MIL-I-70485 (AR)
AMENDMENT 1
13 August 1990

MILITARY SPECIFICATION

INDICATOR, AIRSPEED, AND DIRECTION FIRE AND FLIGHT AIR DATA SUBSYSTEM, HELICOPTER ARMAMENT: M143

This amendment forms a part of Military Specification MIL-I-70485 (AR), dated 30 June 1983, and is approved for use within the U.S. Army Armament, Munitions and Chemical Command, and is available for use by all Departments and Agencies of the Department of Defense.

FIGURE 6 VIBRATION TEST CURVE FOR EQUIPMENT TRANSPORTED AS SECURED CARGO

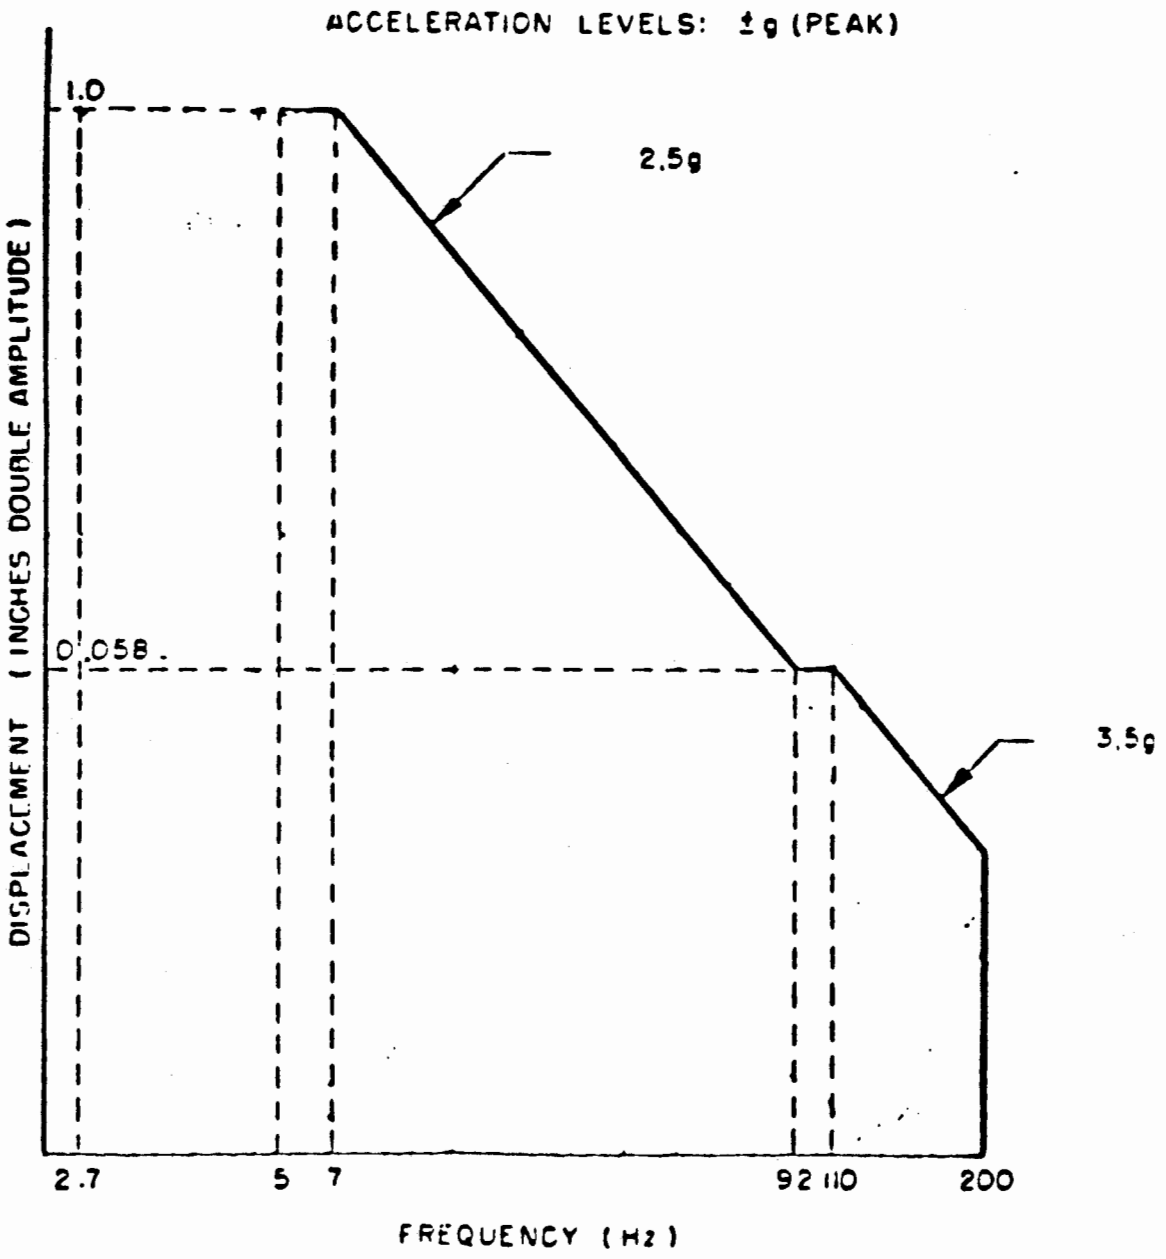
3.4.6: Delete and substitute:

"3.4.6 Transportability. The LAI shall withstand vibration environments encountered during transportation as specified in figure 6.".

4.6.4.10.3: Delete in its entirety and substitute:

"4.6.4.4 Transportability. The LAI shall be unpacked and secured to the vibration table and shall be vibrated along each axis at the sinusoidal frequencies and amplitudes depicted in Fig. 6. The frequency of applied vibration shall be cycled logarithmically from 5 to 200 to 5 Hz, each cycle having a sweep time of 12 minutes. The system shall be exposed to the cycling for 84 minutes per axis. The LAI will not be operated during vibration. At the conclusion of this test, subject the LAI to the performance tests of Table V.".

Add enclosed figure 6 (20A).

NOTE: ALL CURVES SHALL BE EXTENDED TO 2 Hz WHEN TEST ITEM RESONANCES BELOW 5 Hz ARE EXPECTED.
